UCC28700-Q1 unstable switching

Schematics

Phenomenon

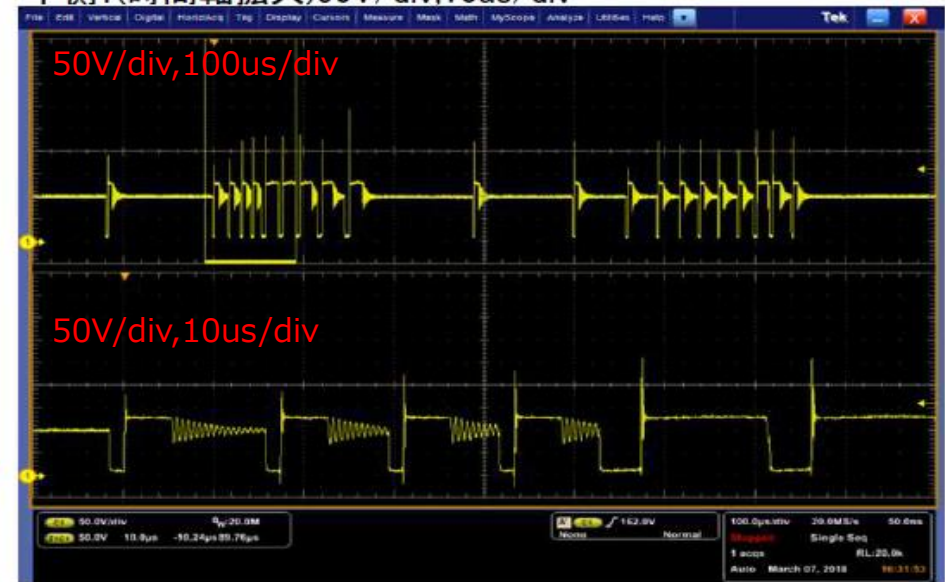
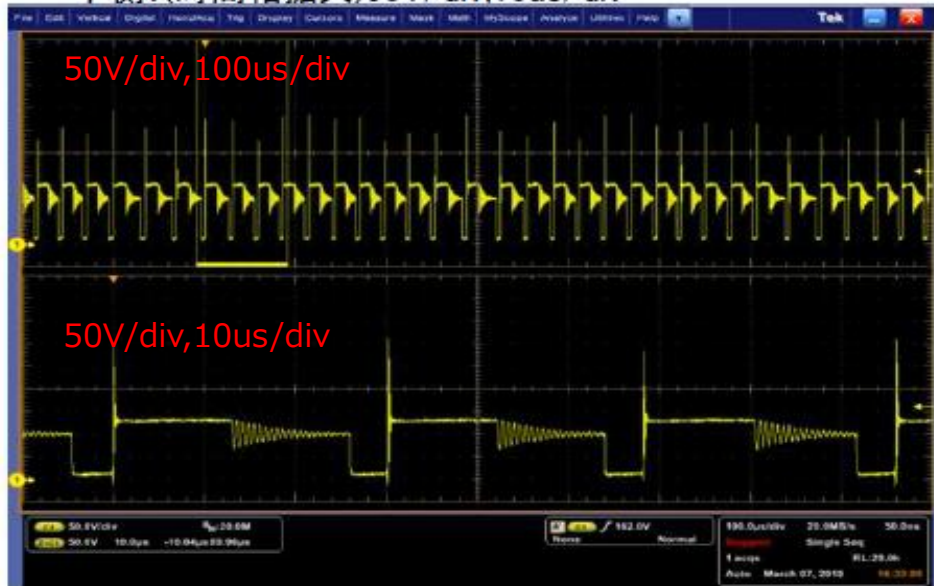
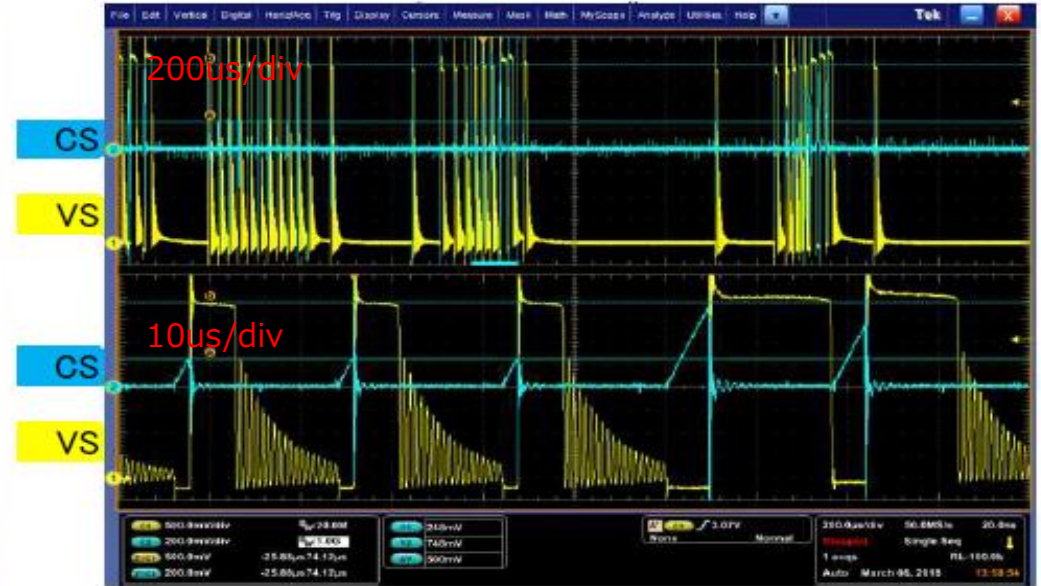
At light load condition(500mA Load), the switching waveform is unstable and big output voltage ripple is occurred. This phenomenon is occurred regardless of whatever the input voltage range. Incleasing Rcs from 142mohm to 270mohm, it resolve this phenomenon. But this solution makes the maximum load current is reduced. They want to know the cause and the solution about this.

1. Stable waveform
   V_BLK=100V
   Iout=0A

2. Unstable waveform
   V_BLK=100V

Iout=0.5A

3. Stable waveform
   V_BLK=100V
   Iout=3A

4. Unstable waveform
   V_BLK=100V
   Iout=0.5A
